**PLANNED UNIT DEVELOPMENT,  
PLANNING APPROVAL &  
SUBDIVISION STAFF REPORT****Date: September 5, 2013**

<b><u>NAME</u></b>	Blue Creek Coal Terminal Subdivision
<b><u>SUBDIVISION NAME</u></b>	Blue Creek Coal Terminal Subdivision
<b><u>LOCATION</u></b>	80 Virginia Street (Area bounded by CSX Railroad, New Jersey Street, Old Water Street, and Mobile River, extending to the North side of Virginia Street, 465'± East of Conception Street))
<b><u>CITY COUNCIL DISTRICT</u></b>	District 2
<b><u>PRESENT ZONING</u></b>	I-2, Heavy-Industry District
<b><u>AREA OF PROPERTY</u></b>	1 lot / 36.9 acres ±
<b><u>CONTEMPLATED USE</u></b>	Planning Approval to allow a coal handing terminal in an I-2, Heavy-Industry District, Planned Unit Development approval to allow multiple buildings on a single building site, and Subdivision approval to create one legal lot.
<b><u>TIME SCHEDULE FOR DEVELOPMENT</u></b>	After appropriate approvals are obtained.

# SITE PLAN

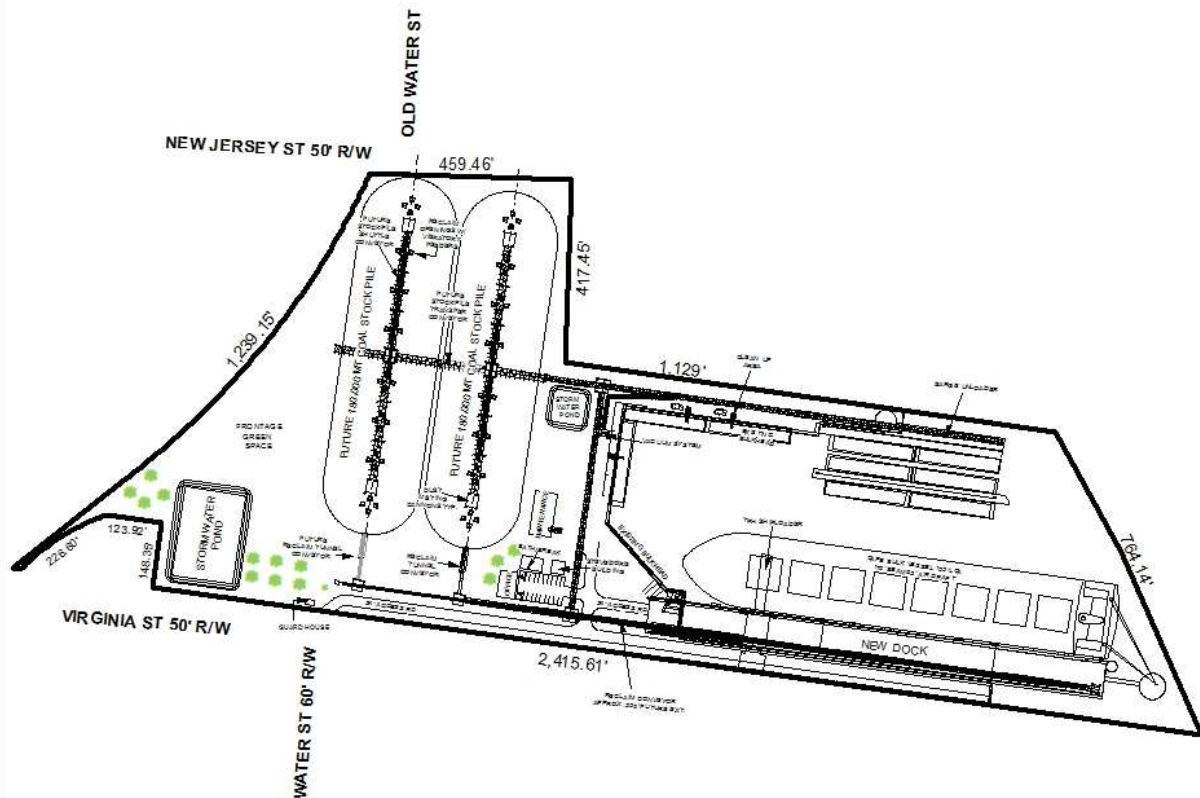
The preliminary plat depicts additional street rights-of-way adjacent to the proposed lot, but information available to staff indicates that the rights-of-way abutting the North side of the site, and that portion of Virginia Street that is East of the proposed entrance to the property have been vacated. The surveyor should verify that abutting rights-of-way have been vacated, and accordingly revise the plat.

The site plan submitted with the application depicts one proposed curb-cut to Virginia Street. As PUD and Planning Approval review are site plan specific, the site should be limited to the single proposed curb-cut, with the size, design and location to be approved by Traffic Engineering, and to comply with AASHTO standards. It should be noted, however, that the presence of a guard building at the entrance to the site implies to staff that the entrance may be gated. If an entry gate is proposed, it should be depicted on the site plan and it should be set at least 60-feet from the right-of-way of Virginia Street so that emergency vehicles will have sufficient room to turn around if necessary.

The site plan depicts trees and landscape areas on the site. As the site is in an I-2 zone, only frontage trees are required. Calculations by staff indicate that 14 frontage trees are required, to be planted within the 25-foot setback along the Virginia Street frontage. Only 13 trees are depicted, and none appear to be within the setback area. Measurements of the site area by staff indicate that the non-navigable water portion of the site is no more than 22 acres of the total 36.9 acres. As such, the landscape area calculations on the site plan should be revised to only consider the dry land area, not any portion of the site over water (such as a dock), or the water area associated with the Mobile River: essentially any area behind the bulkhead should provide the basis for the landscape area calculations. The site plan and calculations should be revised to reflect the reduced landscape area requirements.

The site plan does not indicate which portions of the on-site access road will be paved, versus surfaced with aggregate or other materials. The site plan should be revised to depict paved versus aggregate surfacing. Additionally, the parking area should include concrete wheel stops if no curb-and-gutter will be provided.

The size of the proposed lot on the application was stated as 36.9  $\pm$  acres, while a note on the plat indicates that it is 37.1  $\pm$  acres. The final plat should be labeled with the correct area, in both square feet and acres, as should the PUD and Planning Approval site plans.

Finally, the 25-foot minimum building setback line is depicted on the preliminary plat but is not depicted on the site plans. The site plans should be revised to also depict the 25-foot minimum building setback line.

*Staff has concern regarding the source of water that will be used for dust suppression, and the nature of the surfactants that will be used in the water, and their potential impact on the adjacent Mobile River if they drift or drain into the river.*

- 1) Revision, if necessary, to label the correct size of the lot in square feet and acres, to match that on the final plat;
- 2) Revision of the site plan to depict any proposed entrance gate at least 60 feet from the edge of the Virginia Street right-of-way;

- 3) Revision of the site plan to depict the 25-foot minimum building setback line from Virginia Street;
- 4) Revision of the site plan to depict 14 frontage trees located within the 25-foot minimum building setback;

- 5) Revision of the site plan and landscape area calculations to only provide frontage and total landscape area based upon only that portion of the site that is actual land (that is, behind the bulkhead);

- 10) Development of the site must comply with all local, state and federal regulations regarding development within a flood zone;
  - 11) Revision of the site plan to indicate which portions of the on-site access road and parking area will be paved in asphalt, concrete or similar, versus aggregate;

- 12) Depiction of concrete wheel stops in the parking area if no curb-and-gutter will be provided;
  - 13) Submission of a revised site plan to the Planning Section prior to the signing of the final plat; and
